Access Compliance Report

Public Rights-of-Way

(Curb Ramps)

Intersection ID: 13917	Main Street: MORNINGSIDE_DR	Cross Street: MCCLINTOCK_RD	Location:	N
ADA ID: 203CFD691EFE	Ramp Type: Perp	Initial Pass/Fail: Fail	Overall Compliance: No	Severity Score: 13.75
Codes/Mitigation Info/Possible Solution		Field Measurements/Component Compliance

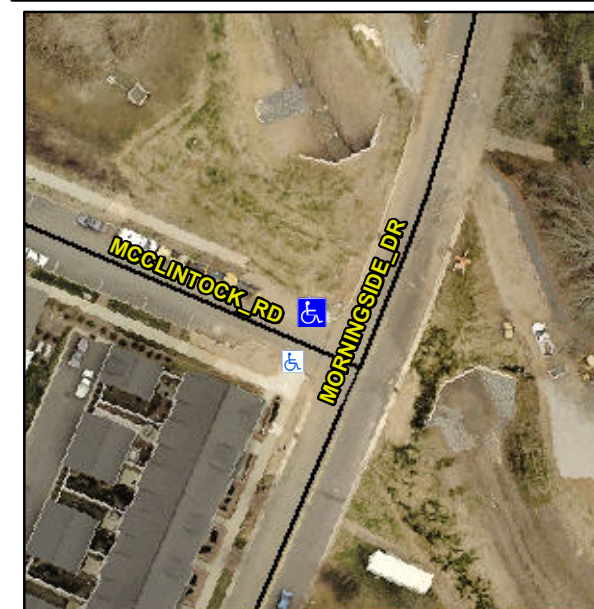
Not Found, R304.2.2, R304.5.3

Compliance	Description	Data	Compliance	Description	Data
N/A	Ramp Length (in)	50.0	No	Ramp Slope (%)	9.3
Yes	Ramp Width (in)	48.0	No	Ramp XSlope (%)	2.6
N/A	Flare Type LT	N/A	N/A	Flare Type RT	N/A
N/A	Flare Slope LT (%)	N/A	N/A	Flare Slope RT (%)	N/A
N/A	Flare Traversable LT?	N/A	N/A	Flare Traversable RT?	N/A
N/A	Landing Length (in)	N/A	N/A	DWS Provided?	N/A
N/A	Landing Width (in)	N/A	N/A	DWS Contrast?	N/A
N/A	Landing Slope (%)	N/A	N/A	DWS Length (in)	N/A
N/A	Landing X Slope (%)	N/A	N/A	DWS Full Width?	N/A
N/A	Landing Curb? (Y/N)	N/A	N/A	DWS Offset (in)	N/A
N/A	Shared Landing?	N/A			
N/A	Gutter Ponding?	N/A	N/A	Gutter Slope (%)	N/A
N/A	Gutter Lip Ht (in)	N/A	N/A	Gutter X Slope (%)	N/A
N/A	Painted X Walk1?	No	N/A	Painted X Walk2?	N/A
	X Walk 1 Direction	To SW		X Walk 2 Direction	N/A
N/A	X Walk 1 Width (in)	N/A	N/A	X Walk 2 Width (in)	N/A
	X Walk 1 Slope (%)	3.9		X Walk 2 Slope (%)	N/A
	X Walk 1 X Slope (%)	5.6		X Walk 2 X Slope (%)	N/A

Remove & Replace Entire Ramp.
